Project Name: Campbelltown Hospital Redevelopment Main works (HI 18467)

RE: REQUEST REMOVAL OF CONDITION B20 (e) – APPIN RD RETAIN EXISTING DECELERATION LANE

APPIN ROAD EXISTING DECELERATION LANE

Figure 3 – Traffic Data for Appin Road

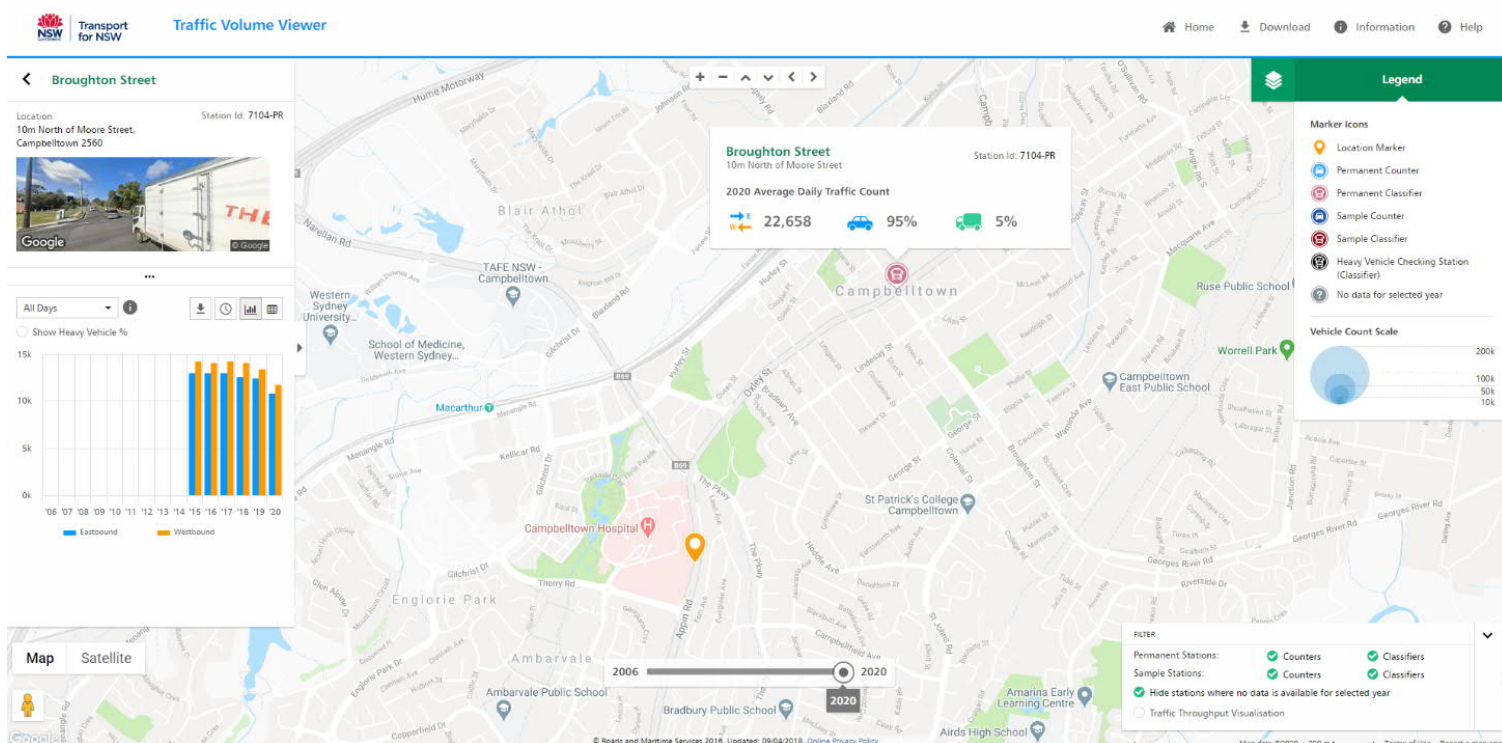
Vehicle counts reveal that Appin Road has an Annual Average Daily Traffic over 20,000 vehicles which will only increase due to expect growth in the Campbelltown Local Government Area. The vehicle numbers from the RMS for a nearby counter which is applicable to the Appin Road deceleration site is shown below in Figure 3

Figure 5 – Additional Road Reserve Draining into the Hospital after Removal of the Deceleration Lane

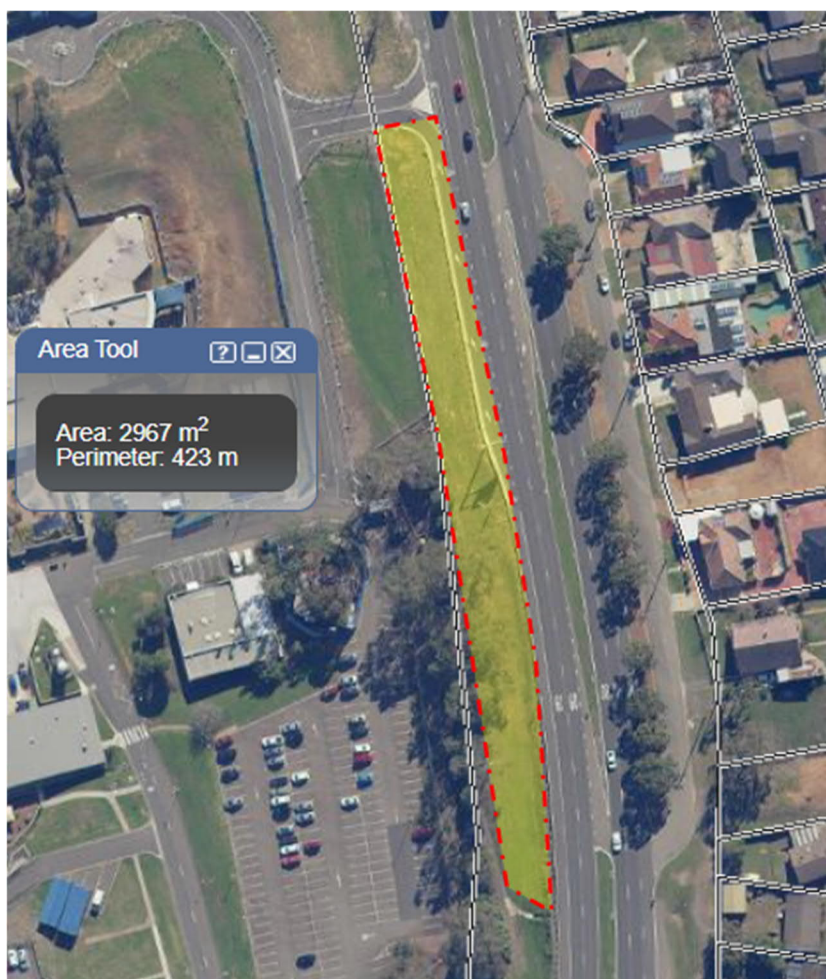
The grassed batter adjacent to Appin Road drains into the hospital campus, the current flows for the 1% AEP storm event is around 70L/s. Removal of the deceleration lane and increasing the batter area draining into the hospital, will increase flows by approximately 5% in to the campus.

Refer to Figure 4 for the existing catchment draining into the Hospital

The proposed deceleration lane reduction in area has been included in the above 5% increase calculations.

Refer to Figure 5 for the catchment draining into the Hospital should the deceleration lane be removed.

Keeping the shoulder will reduce the impact on Appin Road traffic during construction, as well as limit additional stormwater overland flow into the Hospital campus.
